TENNESSEE VALLEY AUTHORITY

In the Matter of the Application of) Docket Nos. 50-327
Tennessee Valley Authority) 50-328

Enclosed is the response to the Accident Analysis Branch question (Bypass Leakage) transmitted by your letter to H. G. Parris dated August 10, 1979. This response will be incorporated in Amendment 62 of the Sequoyah Nuclear Plant Final Safety Analysis Report as Question 6.64.

6.64

FIGURE 6.2-32 AUXILIARY BUILDING PRESSURE
RESPONSE POST LOCA

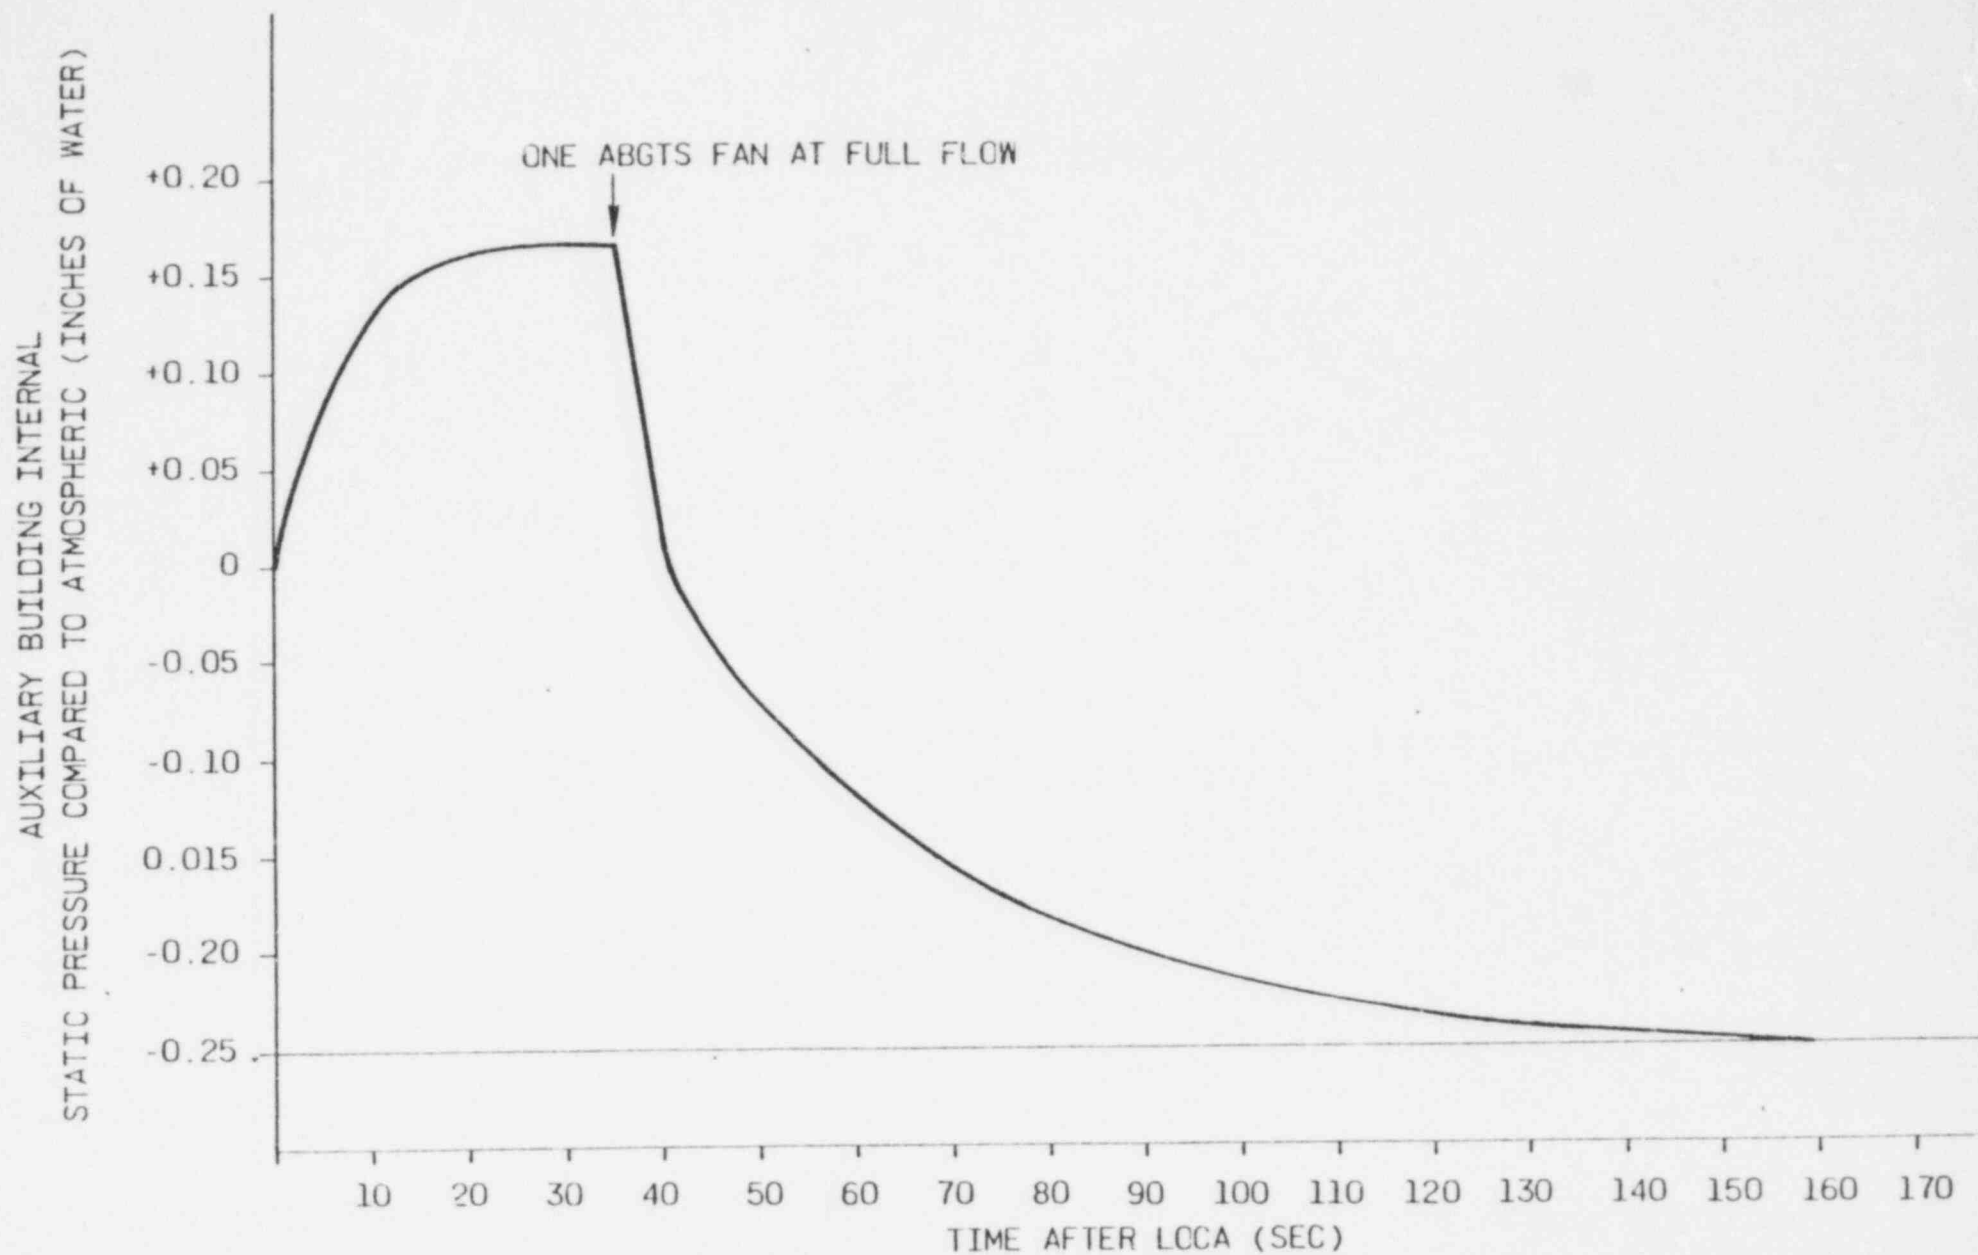
In order for the staff to evaluate the need to allow an additional 5 minutes of bypass leakage at an increased leak rate of 25% of the total containment leakage through the auxiliary building, the applicant is requested to provide a pressure analysis of the auxiliary building during the first 10 minutes into the accident. The analysis should include a pressure response curve of the auxiliary building atmosphere.

See Revised Section 6.2.3.3.3

A performance analysis to determine the capability of the Auxiliary Building Gas Treatment System to establish and maintain a negative pressure in the Auxiliary Building Secondary Containment Enclosure (ABSCE) was based on the following assumptions:

1. Infiltration into the ABSCE is equal to 6000 cfm at a negative pressure differential of 1/4-inch water gauge. This infiltration rate is conservative since the ABSCE is designed to limit this rate to 4500 cfm.
2. Only one air cleanup unit of the Auxiliary Building Gas Treatment System operates, and it operates at its rated capacity of 9000 cfm.
3. The air cleanup unit fan begins to operate 30 seconds after initiation of the LOCA and reaches full flow in 5 seconds.
4. The initial static pressure inside the ABSCE is assumed to be equal to atmospheric pressure. This is a conservative assumption since the ABSCE is under a negative pressure during normal operation.

5. The wind pressure head equals 1/8-inch water gauge.
6. The initial ABSCE air temperature equals 104°F.
7. Atmospheric temperature and pressure are 97°F and 14.4 psia, respectively.
